URGWOM Rules Review

version 4.1.1

Technical Team DRAFT

March 2010

Figure 2.1. MRGCD Demand at Cochiti

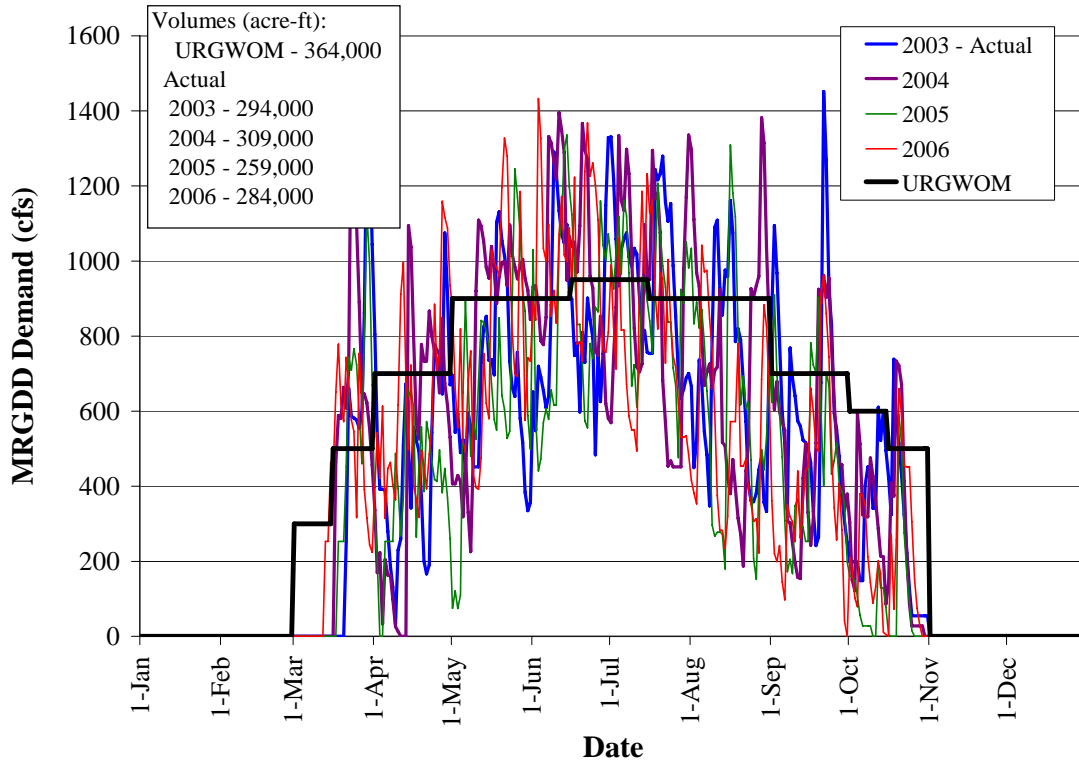
As depicted in Figure 2.1, the volume of the annual MRGCD demand curve in URGWOM is higher by approximately 28 percent than the average of the historical demand from 2003 through 2006 and reflects a limited ability in actual operations to exactly meet an identified demand due to the uncertainty about flows from the mainstem, conveyance losses, etc. combined with the travel time from El Vado Reservoir to Cochiti Reservoir and to the diversion locations along with other physical operational constraints. If a consumption driven approach was set up in URGWOM for setting MRGCD diversions and the demand at Cochiti, a safety factor would likely need to be applied to the results such that water needs from El Vado Reservoir match historical volumes.

Figure 2.6. Criteria Checked Daily when Setting the Albuquerque Diversion Requested

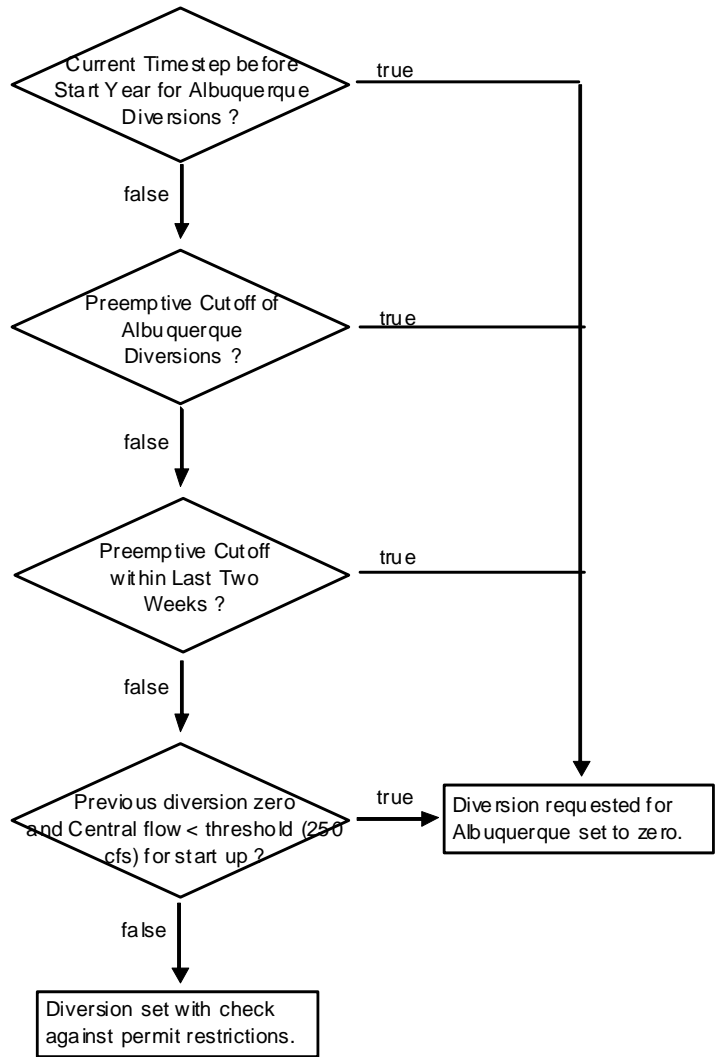
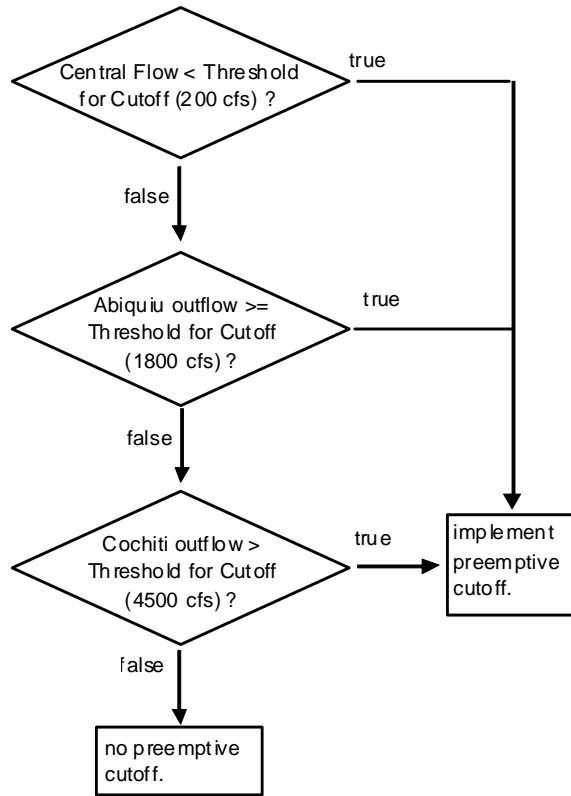
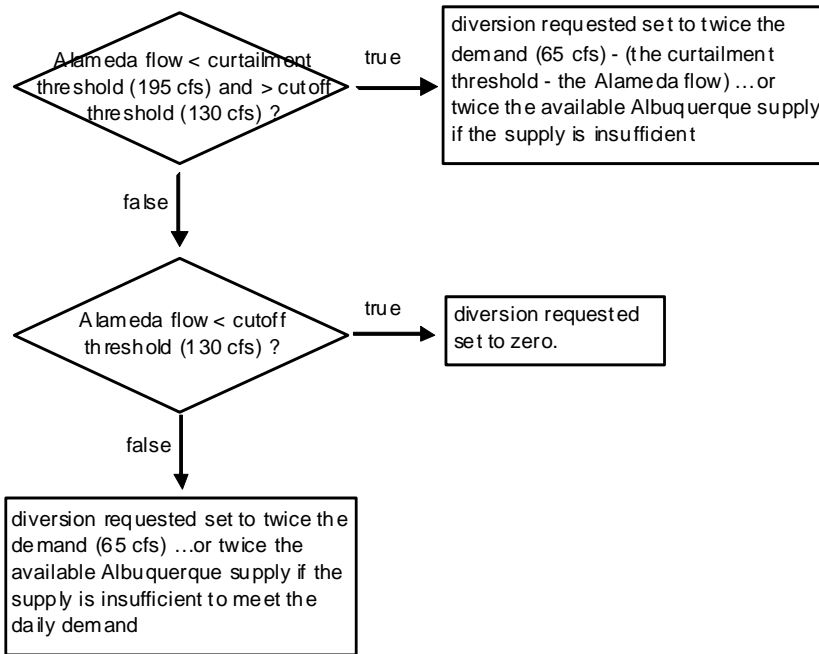
A potential needed change to the coded policy in URGWOM may be to include an exchange that allows for Albuquerque to continue surface water diversions when Abiquiu Dam is operating for channel capacity and only native Rio Grande water is being released. Such an exchange would entail allowing Albuquerque diversions to continue when Abiquiu Dam is operated under channel capacity restrictions, and Albuquerque could accrue a debt that would be paid back with their San Juan-Chama Project water after flood control operations have ceased. Details on the timing for such a payback would need to be identified.

Figure 3.2. Flow Chart Depicting Logic for Setting San Juan Diversions

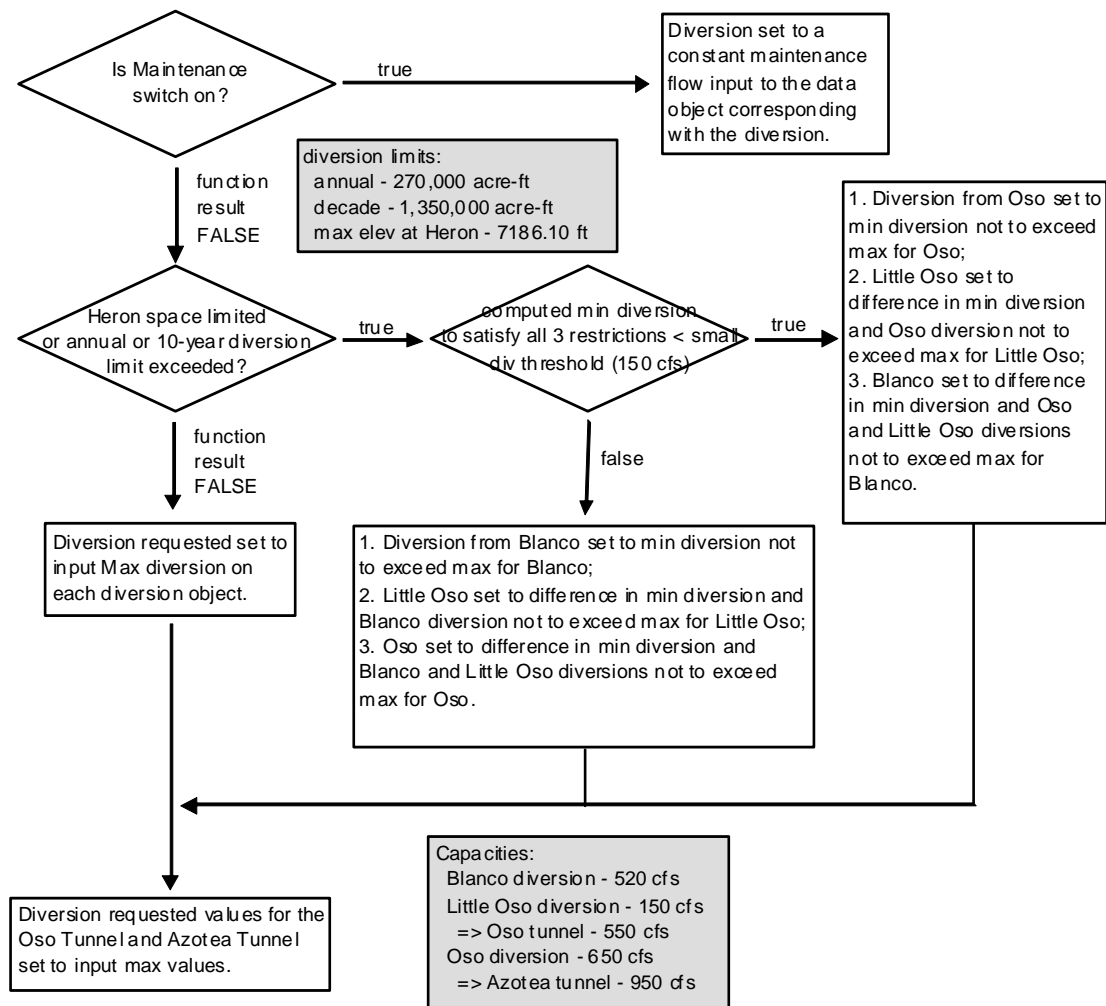
URGWOM includes a detailed representation of the policy for setting diversions from the San Juan basin. Including such detail results in the rules accurately setting diversions with consideration for the capacity at each tunnel which may actually result in the full diversion capacity at the Azotea tunnel from being reached. It is good to have the detail in regards to the diversion capacities such that the yield from the diversions is determined accurately in the model.

Based on simulations completed with the Planning Model using the five synthetic hydrologic sequences (Roach, 2009), diversions are never curtailed based on the annual diversion limit of 270,000 acre-ft and the decade diversion limit of 1,350,000 acre-ft; however, Heron Reservoir may fill to the maximum pool elevation of 7186.1 ft (or a

This situation of Heron Reservoir being full and resulting in curtailed San Juan diversions serves is an excellent example of the type of situation that could cause a change in policy. The system may be operated in a different manner under conditions that simply are not actually known since managers that deal with day-to-day operations have not had to consider such a situation. Operations could be adjusted if possible to move some water in Heron Reservoir to downstream storage space and create space at Heron Reservoir for San Juan-Chama Project water, but there may be interest in leaving space available in El Vado Reservoir to capture the runoff of native Rio Grande flows and Abiquiu Reservoir may already be nearly full to the maximum pool elevation of 6220 ft.

Figure 4.4. EIVadoData.MaxAccountStorage Periodic Slot

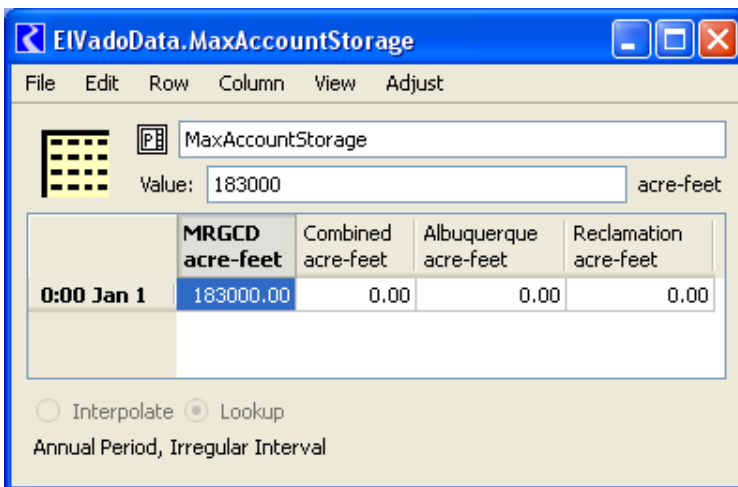
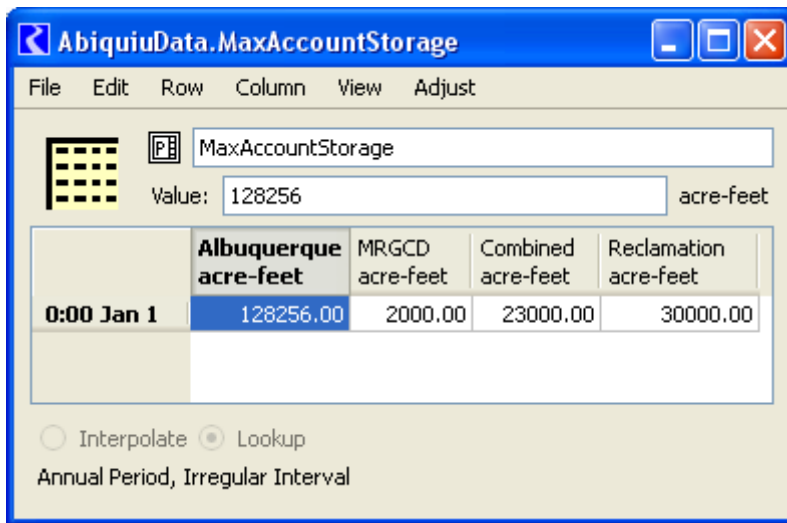
Having rigid established amounts of allocated storage space for an entire simulation may not be a problem for a Water Operations Model run that simulates operations through the end of one calendar year, but more flexibility is needed for longer term simulations. Planning Model simulations have historically been completed for 10-year periods or longer, and storage space for contractors would not realistically be so set so rigidly for such a long period. Also, the current situation with Albuquerque not needing as much storage space in the near future specifically increases the need for more flexibility to vary allocated storage space within a Planning Model run. Albuquerque will need less and less storage space at Abiquiu Reservoir with the startup of their surface water diversions and increased letter water deliveries to payback for past pumping. More space will then be available for other contractors.

Figure 4.7. HeronData.AccountReleasePriority Periodic Slot

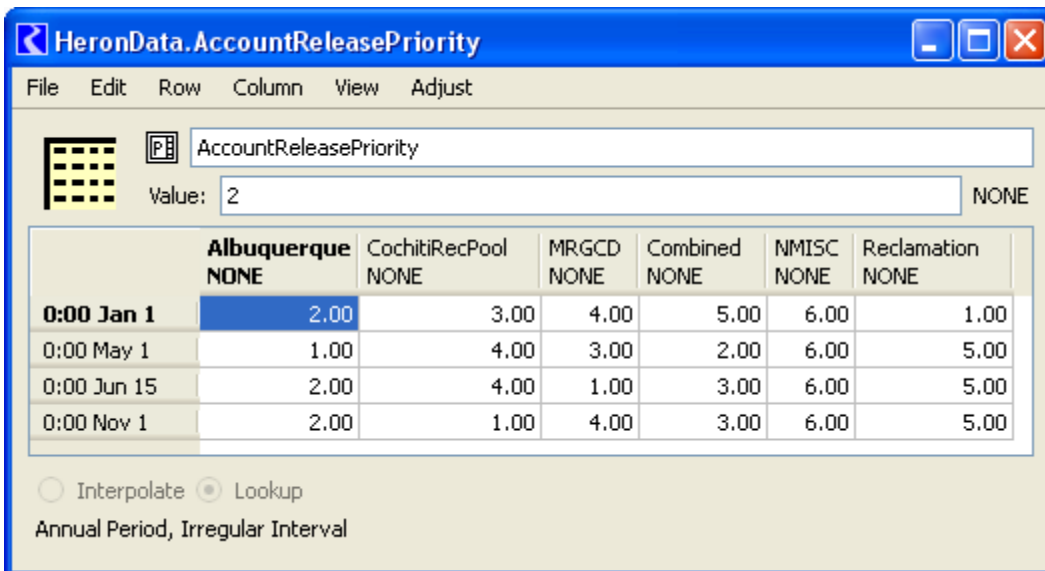
After a release type is identified, different accounts with that release type are set based on the account priority table (Figure 4.7). One problem with the coded approach is that there is often a need to have deliveries made at the same time for two different accounts that have the same release type, but the setup only allows deliveries with the same release type to be set sequentially. For example, during a dry period, there may be a need to deliver allocated San Juan-Chama Project water to fill downstream allocated storage space for both Albuquerque and MRGCD at the same time. (This is accomplished in the current model but is done with separate accounts not included as part of the initial total release. Specific accounts designated with a release type of AccountDelivery are set to assure MRGCD's allocated storage space is filled, but downstream demands included as part of the initial total outflow are then not met as a result.).

Figure 7.6. Flowchart for Implementing Cochiti Deviations

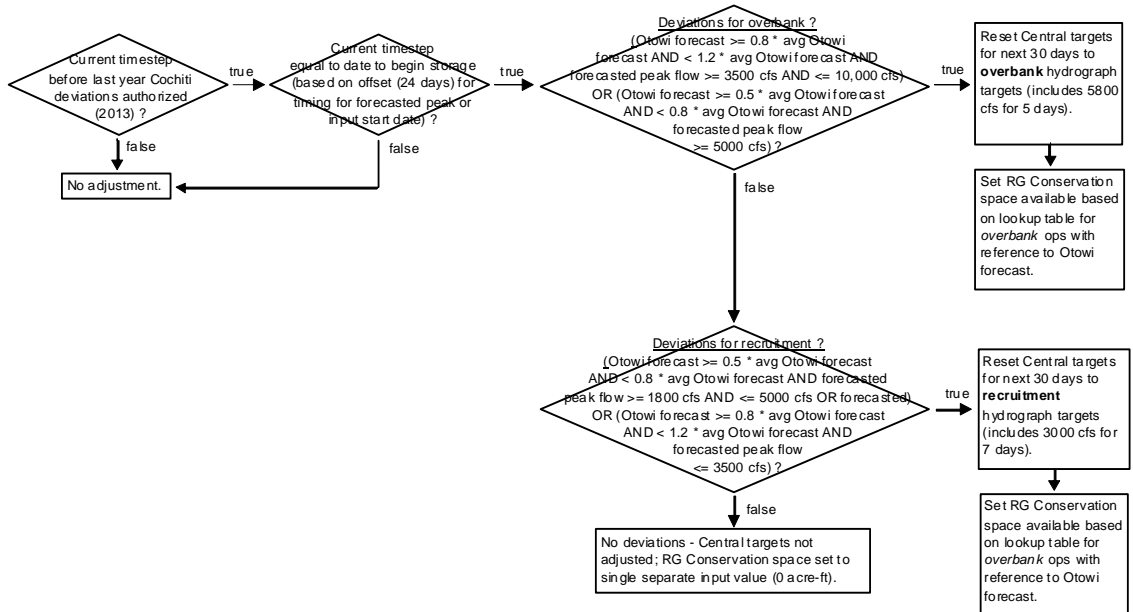
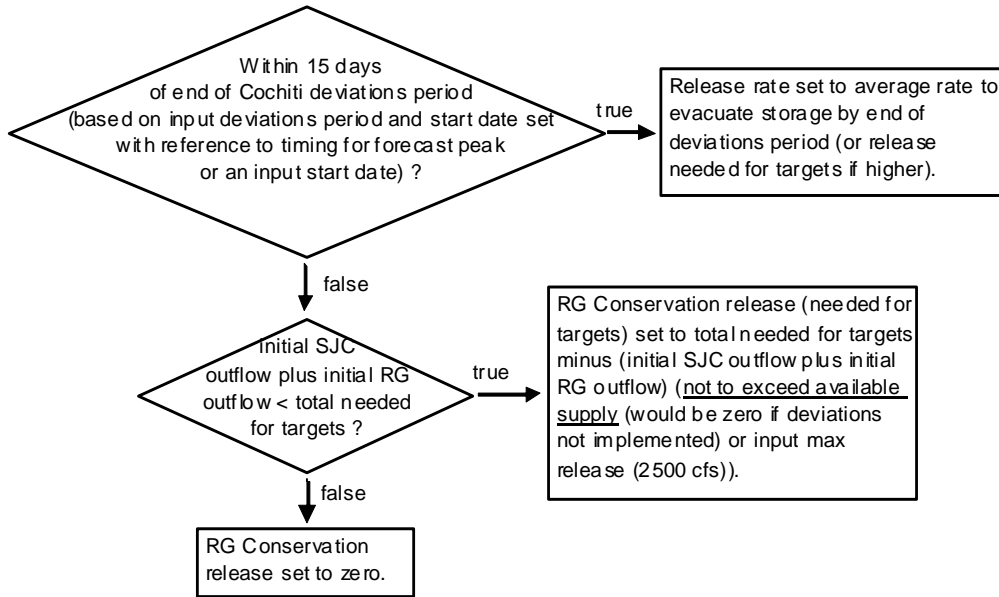
One result that may need to be addressed is that rules for stepped releases may prevent outflows from decreasing quickly enough following the peak deviations targets. The additional outflow as a result of releases not being stepped down quickly enough may cause the storage in the Rio Grande account to go negative. The negative storage is quickly offset as part of the Rio Grande storage adjustment (Figure 7.2), but a modification may need to be applied to prevent stepped releases from controlling in the model as operations for Cochiti deviations are ceased. Actual operations would be conducted in a manner to prevent stepped releases from controlling operations. Related to this effect, the storage adjustment function may result in significant storage at Cochiti Reservoir to offset for the negative Rio Grande storage and this adjustment may cause downstream demands to not be met. Model results would only be impacted by this adjustment for a day or two but the storage adjustment should probably be modified such that downstream demands are met before negative Rio Grande storage is corrected.

Depending on the importance of the target flows at Central, a tolerance (e.g. 100 cfs) could be added to peak targets in the target hydrographs to assure the downstream targets are definitely met. Note that the safety factor applied to targets as discussed in section 2.4.2 is not applied to Cochiti deviations targets.
